# CITY OF ALBUQUERQUE

**RE: Mia Huynh  
6206 Tesuque Dr. NW  
Grading and Drainage Plan  
Engineer's Stamp Date: 02/19/19  
Hydrology File: E10D057**

Based upon the information provided in your submittal received 02/22/2019, the Grading and Drainage Plan is approved for Building Permit and Grading Permit.

| TITLE: 6206 Tesuque Dr. NW Grading & Drainage Plan |                        |  |                 |

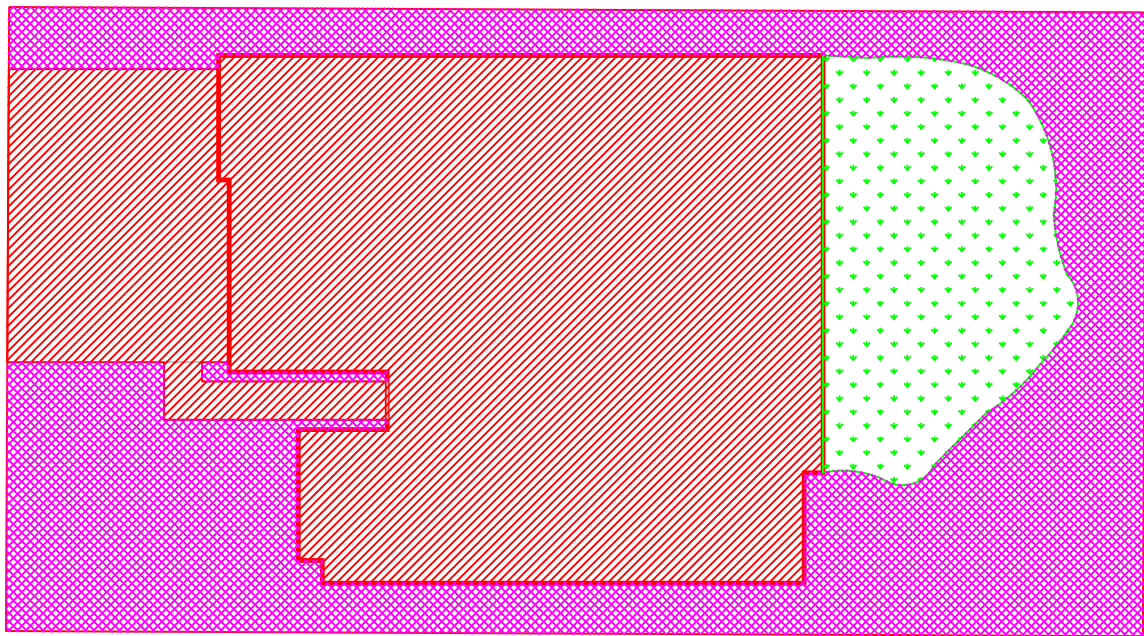
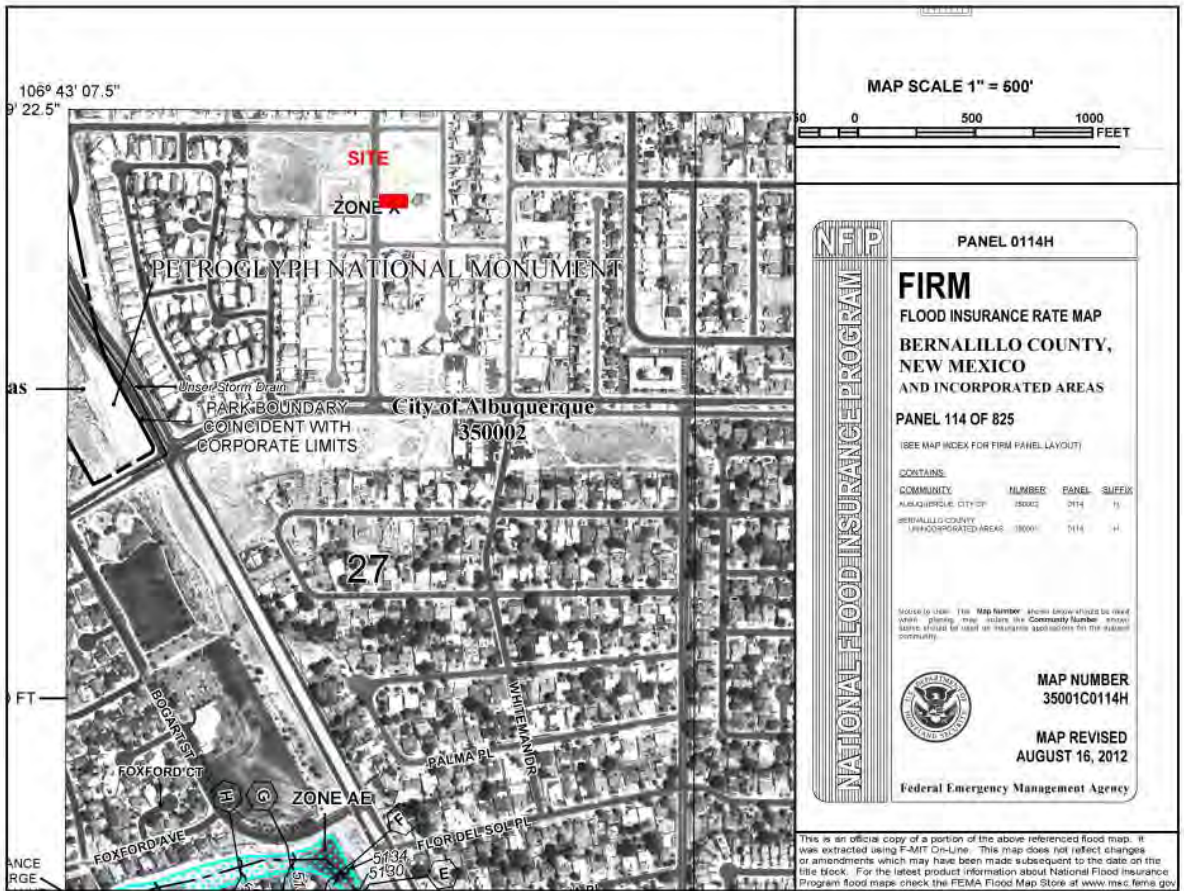
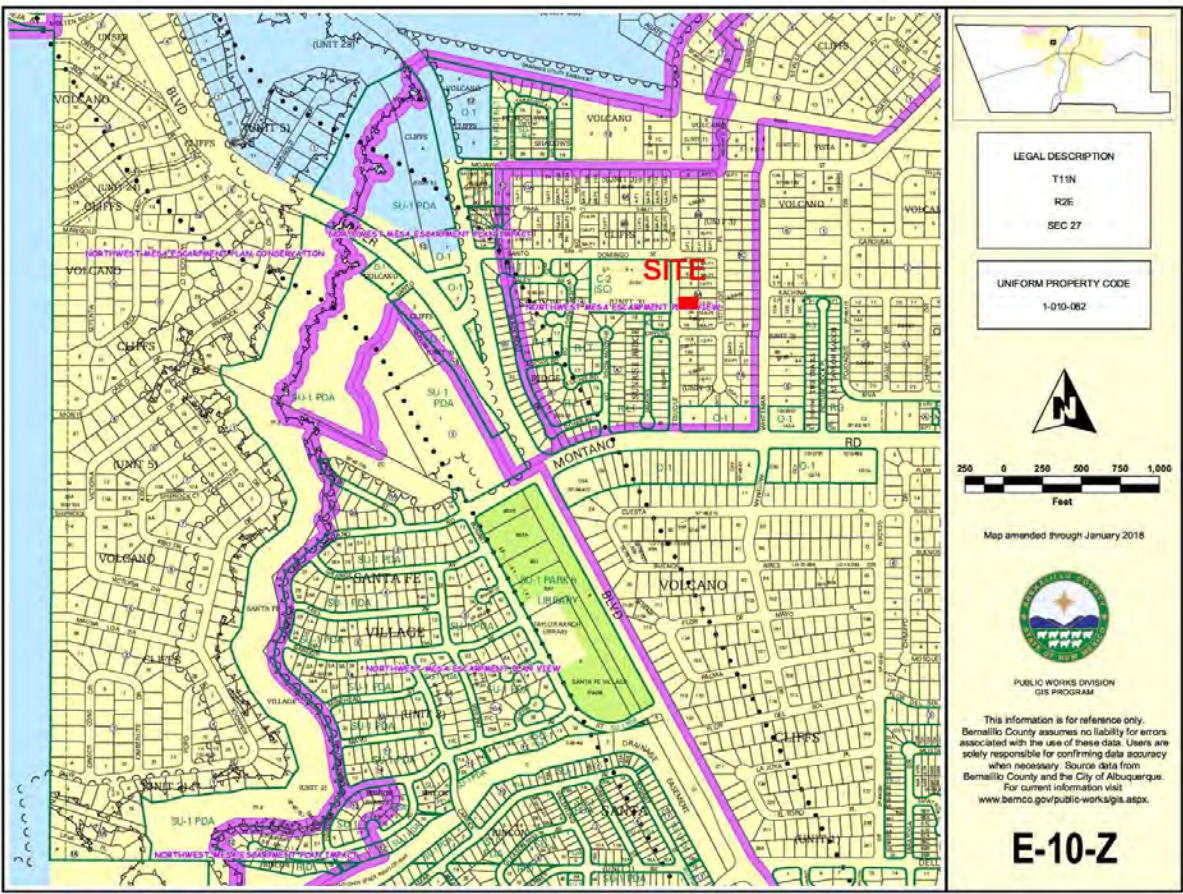
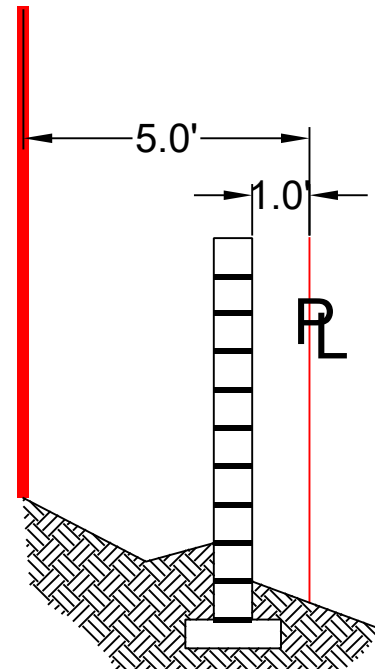
Please note that prior to Building Permit, an Engineer's Certification of the compacted pad and grading, per the DPM Chapter 22.7: Engineer's Certification Checklist For Non-Subdivision is required.

Please attach a copy of this approved plan in the construction sets for Building Permit processing along with a copy of this letter. Prior to approval in support of Permanent Release of Occupancy by Hydrology, Engineer Certification per the DPM checklist will be required.
